Havant Thicket Main Pipeline Works

Non-Material Amendment Technical Note

Rev: S4.P02

Document Status: S4
Document Reference: HTR-WAB-PI-ZZ-TN-W-0016

Figure 2: Shaft ED piling extents. Consented (left, shown in red) and proposed (right, shown in orange and red). Left drawing provided by WAB, right drawing taken from Figure 3 of the WAB NMA Technical Note (2026).

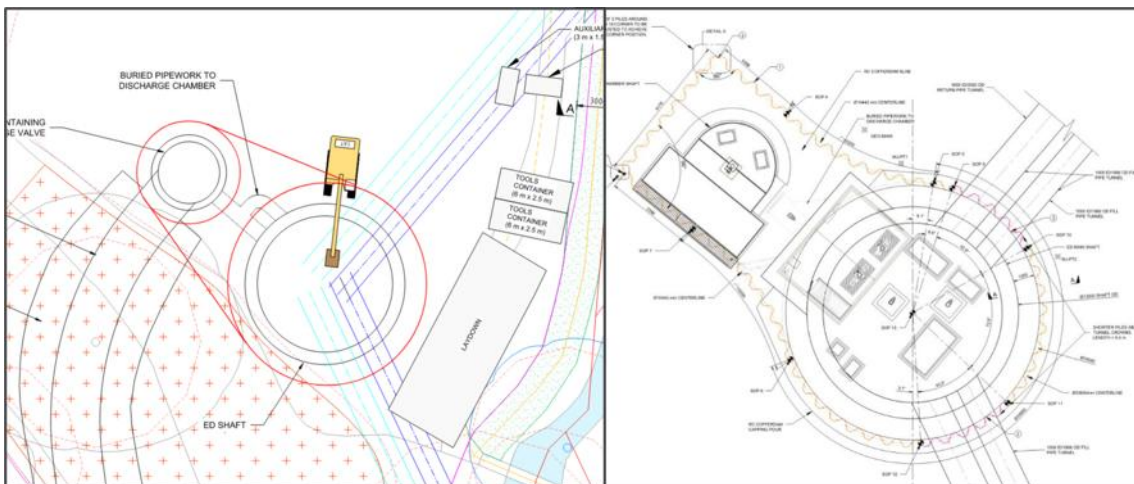
The revised ED Shaft design allows installation using silent piling techniques. The additional silent piling works (hydraulic jacking) would generate noise levels no more than 10 dB below the overall Activity Noise Level for the ED Chamber and, as such, would not result in any increase in construction noise or vibration.

Figure 1 presents the consented (left) and proposed (right) piling alignments and extents for Shaft 6. Figure 2 presents the consented (left) and proposed (right) piling alignments and extents for Shaft ED.
